Joshua Heights

Bridgewater, Connecticut

Environmental Review Team Report

**for the
Inland Wetlands Commission
Bridgewater, Connecticut**

Figure 4

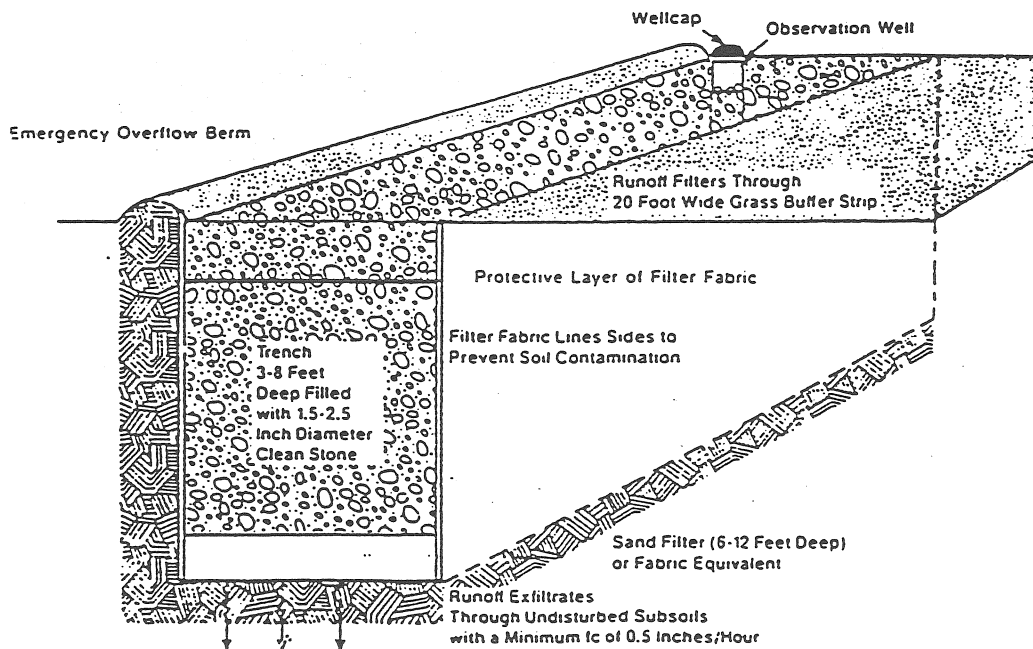
After considering the nature of this site and the high value of the wetland resource to be protected, the most appropriate and effective BMP for this location may be what is called an "infiltration trench" (refer to Figure 4 for further information). This system would utilize the well-draining characteristics of the natural soils here, while at the same time re-introduce a portion of the stormwater back into the ground to flow more naturally as groundwater into the adjacent wetlands. This infiltration trench would accept only the "first flush" of stormwater that contains a majority of the pollutants, typically that volume which equals the first one inch of impervious runoff. Prior to flowing into the trench, stormwater should be pre-treated by one of the "new generation" sedimentation chambers now out on the market. These new designs limit re-suspension of collected sediments and allow for "first flush" stormwater by-passes. Other criteria include a maximum 8% slope, flat bottom trenches and two feet separation to the water table. Use of this BMP may require the re-designing of a small portion of this site to accommodate the above stated guidelines.

A conventional infiltration trench is a shallow, excavated trench that has been backfilled with stone to create an underground reservoir. Stormwater runoff diverted into the trench gradually exfiltrates from the bottom of the trench into the subsoil and eventually into the water table.

Enhanced infiltration trenches have extensive pretreatment systems to remove sediment and oil. They require on-site geotechnical investigations to determine appropriate design and location.
